# Port Kembla Gas Terminal Submissions Report

February 2019

## 1.2 Purpose and structure

Gas Pipeline Comparison

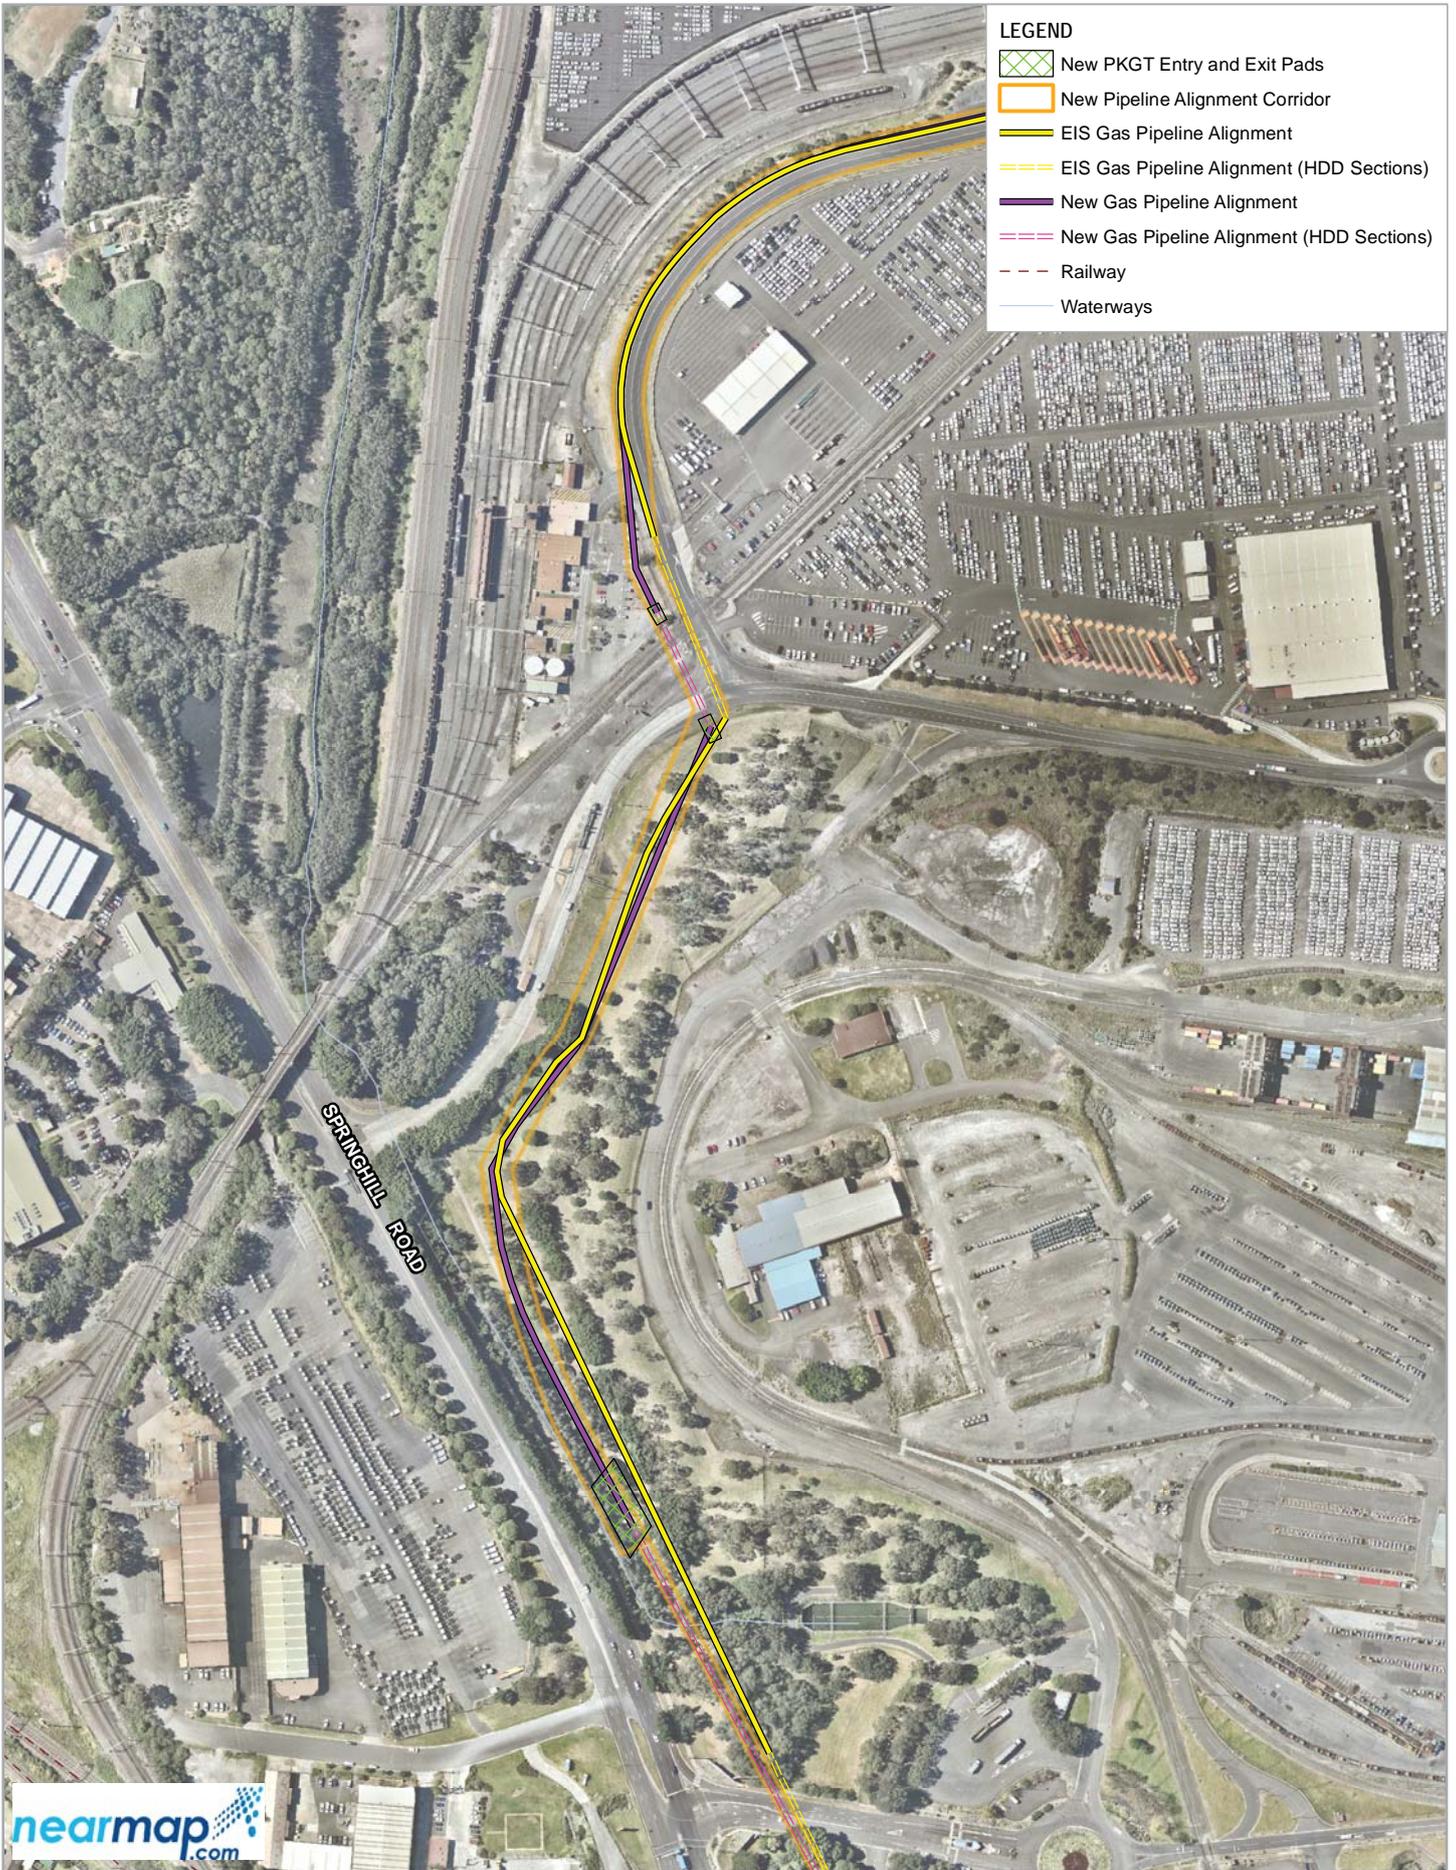
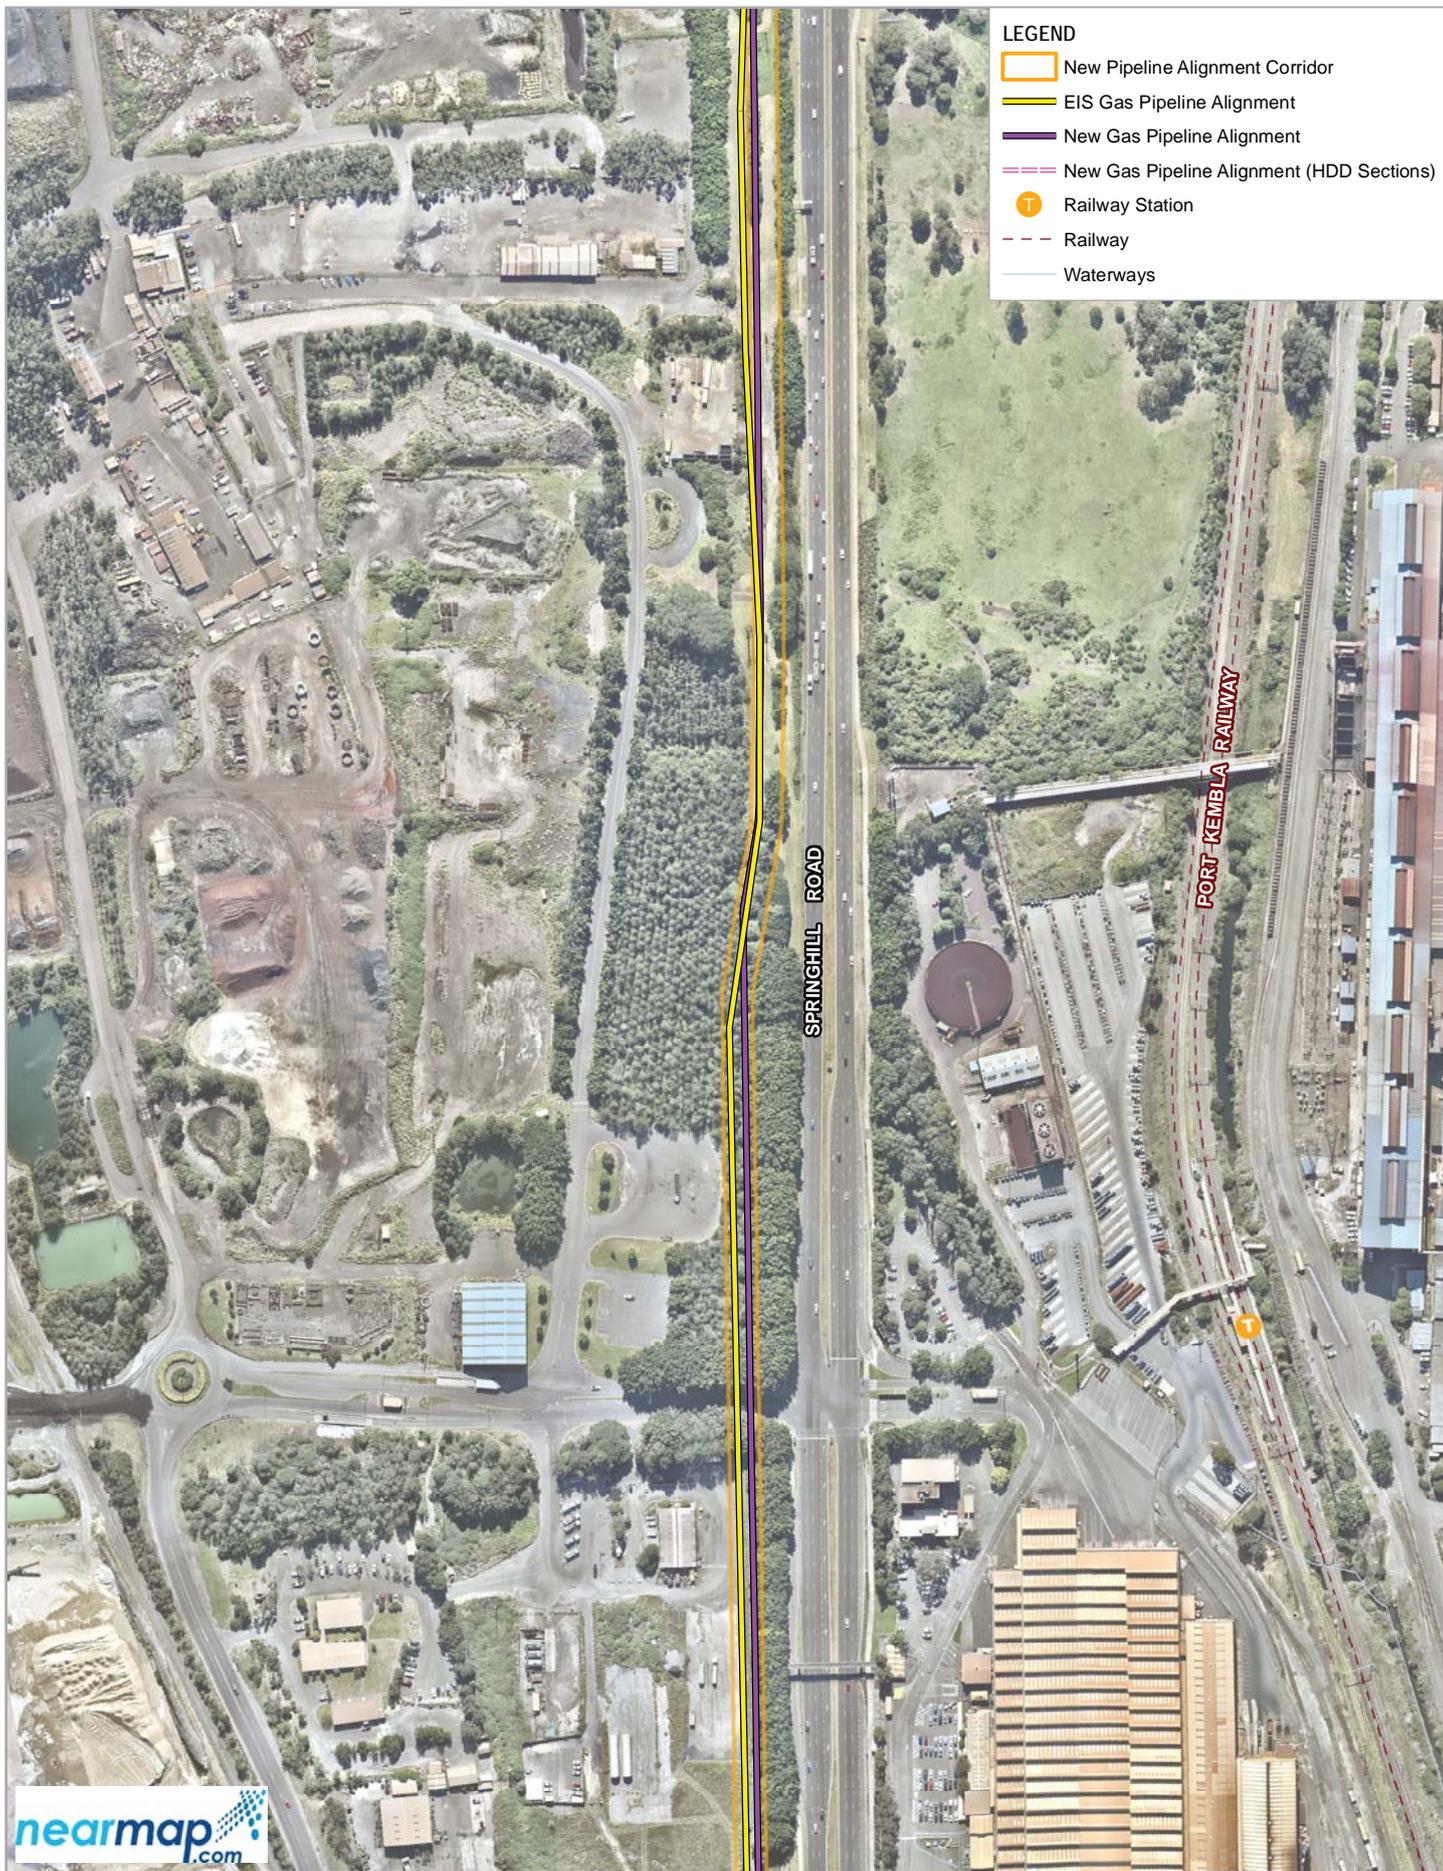
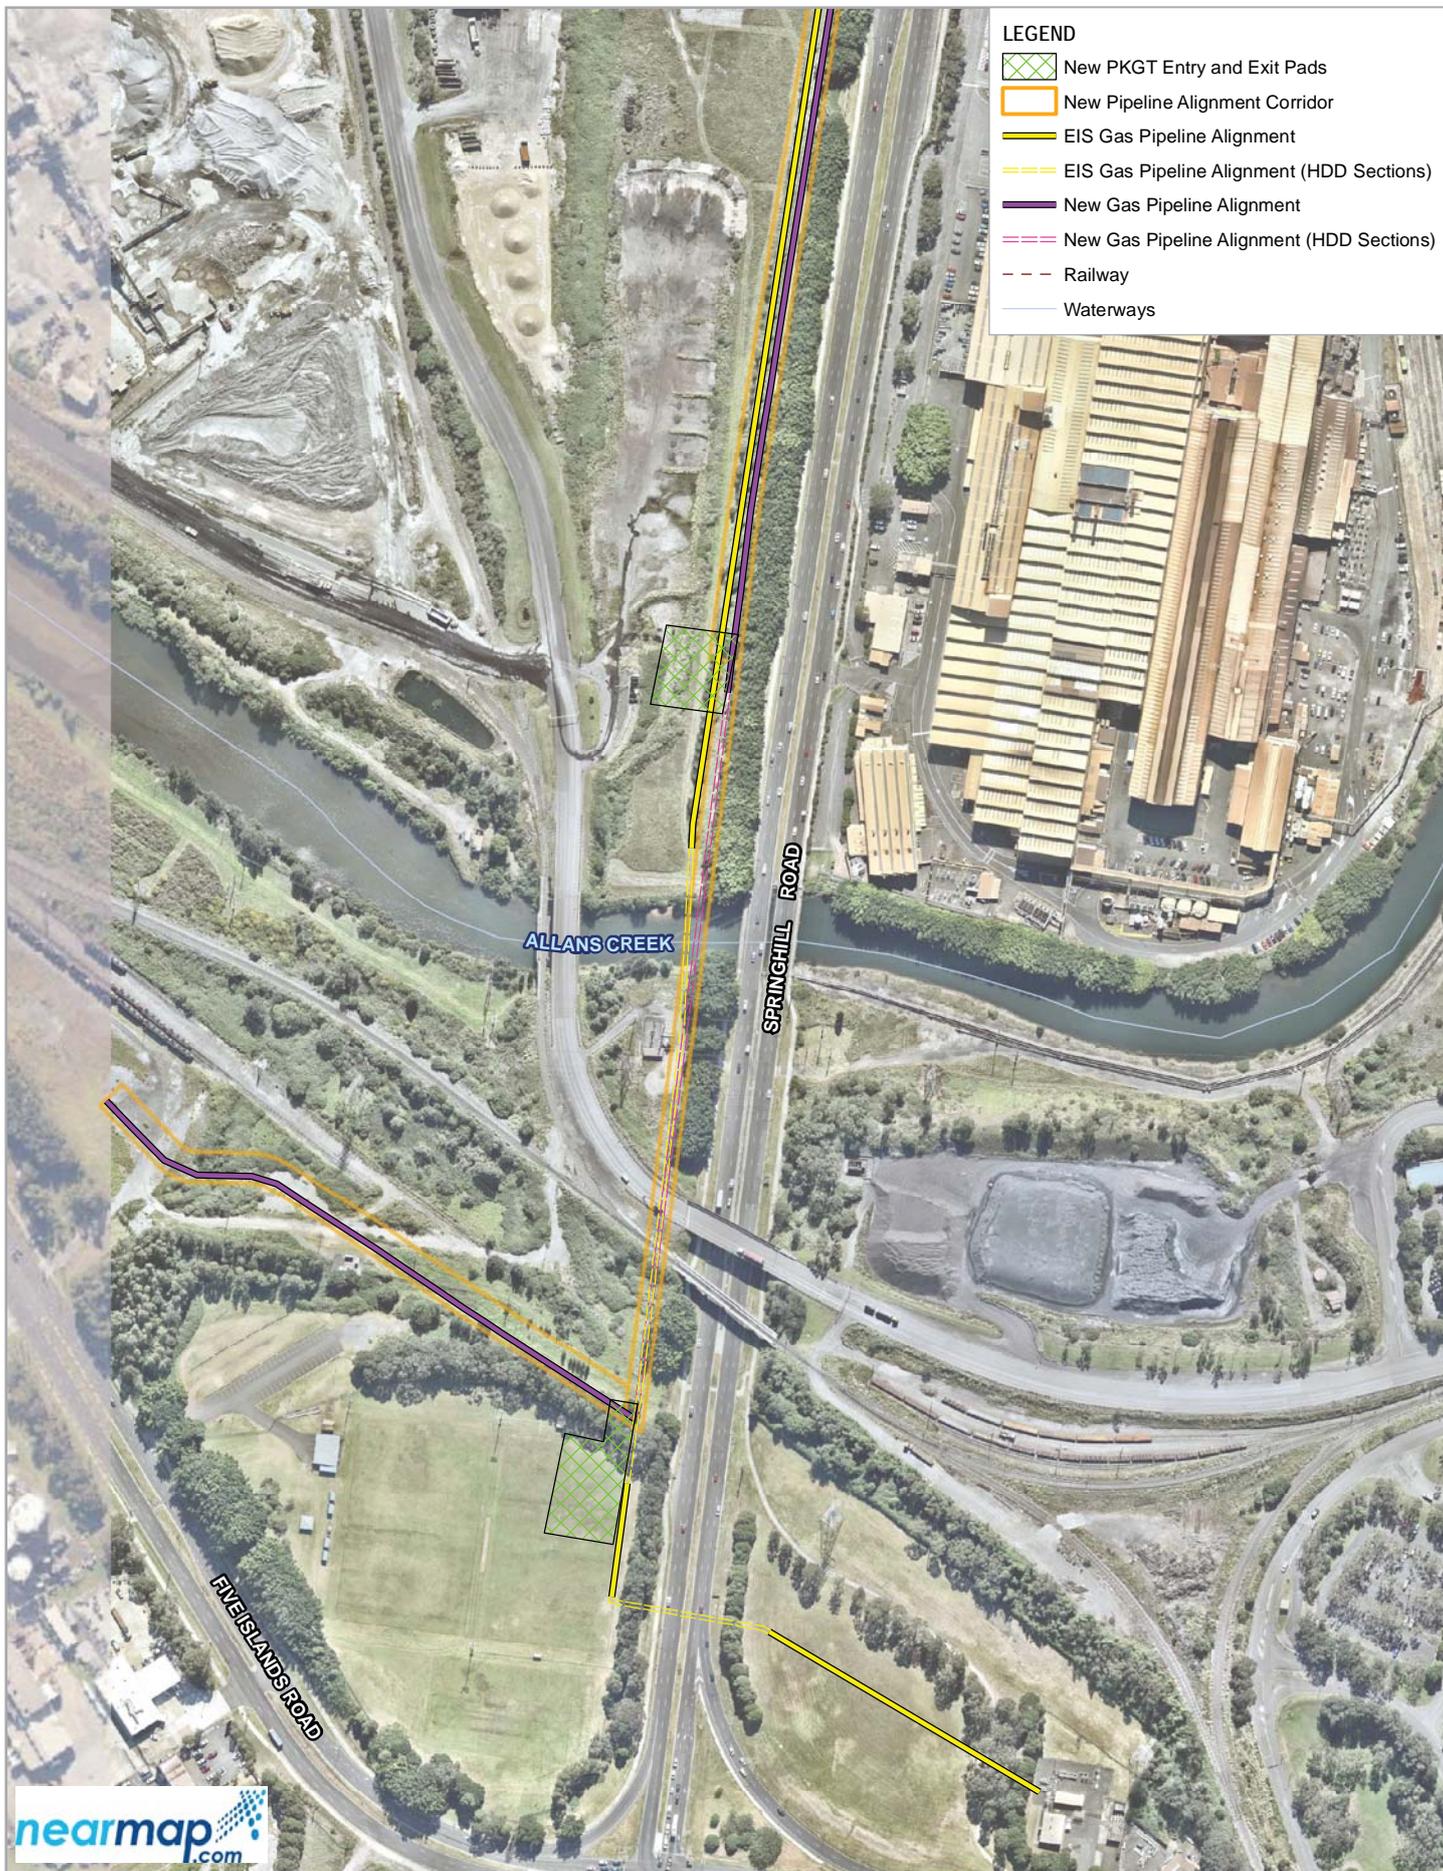
The alignment of the gas pipeline will remain substantially in accordance with the development described in the EIS. Minor modifications are proposed to address comments during ongoing consultation with land owners and key stakeholders during the detailed design process. A detailed comparison of the proposed design changes is included in Figure 3-1 and described below.

A modification is proposed to the alignment of the major directional drill passing beneath NSW RailCorp's South Coast Line and Springhill Road and the intervening vegetated area. The alignment has been modified to allow a more perpendicular crossing of road and rail infrastructure and to allow the pipeline to be strung within the defined construction corridor adjacent to Masters Road, prior to pulling back through the borehole during pipeline installation. Allowance for pipe stringing within the transmission line corridor adjacent to Masters Road has been explicitly shown within the construction footprint.

The EIS described the likely tie in point to the existing gas network to be located at the existing metering station at Cringila or an alternative location along the EGP spurline. An alternative location for the tie in has been identified within cleared land owned by Bluescope and on the existing spurline to the west of Springhill Road as shown on Figure 3-1. This will avoid the need for a final directional drill crossing of Springhill Road and the final approximate 200 m section of pipeline to the metering station.

Refinement to the location and expected footprint of the directional drill entry and exit pads has been developed as part of the detailed design with the likely configuration and construction footprint for all proposed entry and exit pads included on Figure 3-1.

The potential environmental impacts associated with the modified pipeline alignment are predominantly as described within the EIS. The design modifications are minor and will not alter the environmental outcomes described as part of the assessment process.

**Figure 4-1 Near bed temperature impact – Summer (no BlueScope discharge)**

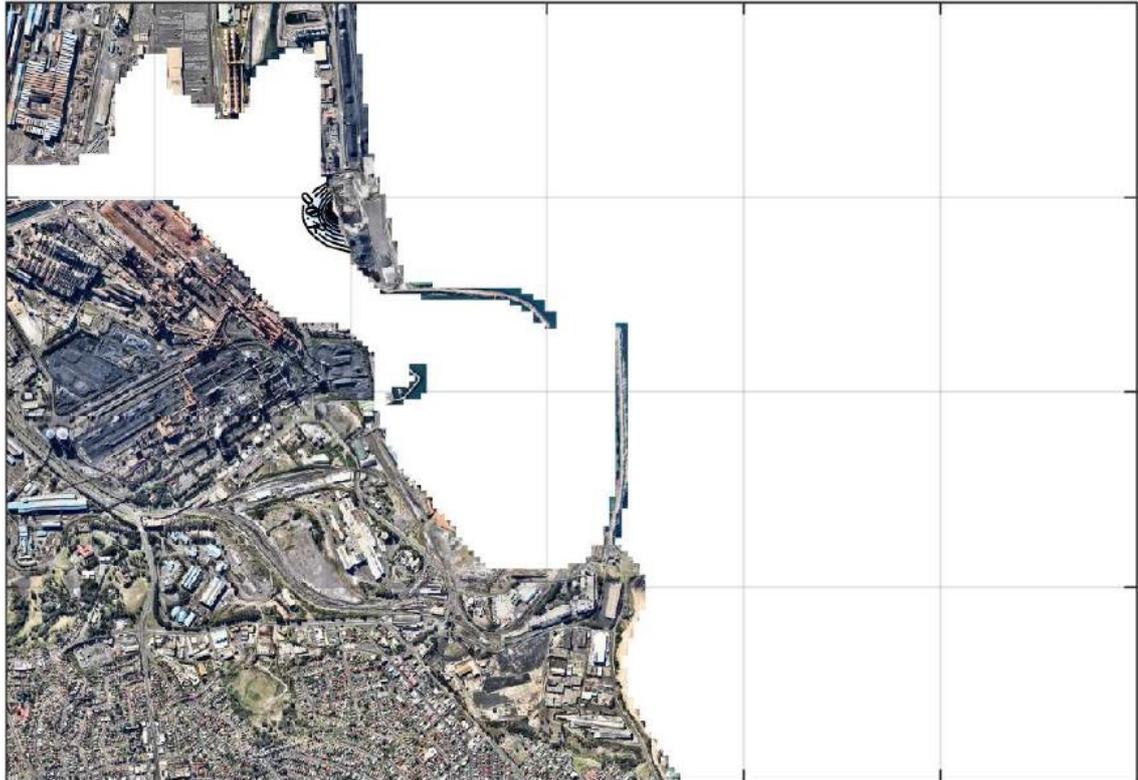
<p><b>Chlorine discharge criteria</b></p> <p>The submission queries the assessment and adoption of the appropriate criteria to assess the levels of chlorine discharge and other by-products from the marine growth protection system during operation of the FSRU.</p> <p>The submission states that the use of the adopted criterion from the IFC World Bank Guidelines for chlorine of 200 micrograms per litre was not appropriate for assessing potential environmental impacts. It stated the assessment should be revised to align with the adopted NSW water quality objectives that align with the Australian and New Zealand Environment and Conservation Council water quality guidelines.</p> <p>It also makes reference to the US EPA guidance for acute risk to marine waters at 13 micrograms per litre and chronic risk at 7.5 micrograms per litre. It notes that a discharge at 200 micrograms per litre would be significantly above those criteria at the point of release.</p>	<p>Section 4.2.1</p>

Plots showing the extent of the non-complying cases are presented in Figure 4-1 and Figure 4-2 comparing the 50th percentile temperature from the FSRU only (i.e. no BlueScope discharge) simulations to the 20th Percentile ambient conditions. Areas shown in blue are colder than the 20th percentile ambient temperatures and are therefore colder than the allowable limits specified in the ANZECC guidelines. From examination of the plots it is apparent that the area predicted to be colder than the allowable limits specified in the ANZECC guidelines is restricted to an area measuring approximately 50m by 100m immediately adjacent to the FSRU. Given that the nearfield mixing zone is predicted to have a radius of up to 42.5m (diameter of approximately 85m area), the predicted zone of non-compliance is considered to be approximately within the nearfield zone given that the far field model resolution is in the order of 30m. For completeness, a plot representing the complying cases for all complying scenarios is presented in Figure 4-3.
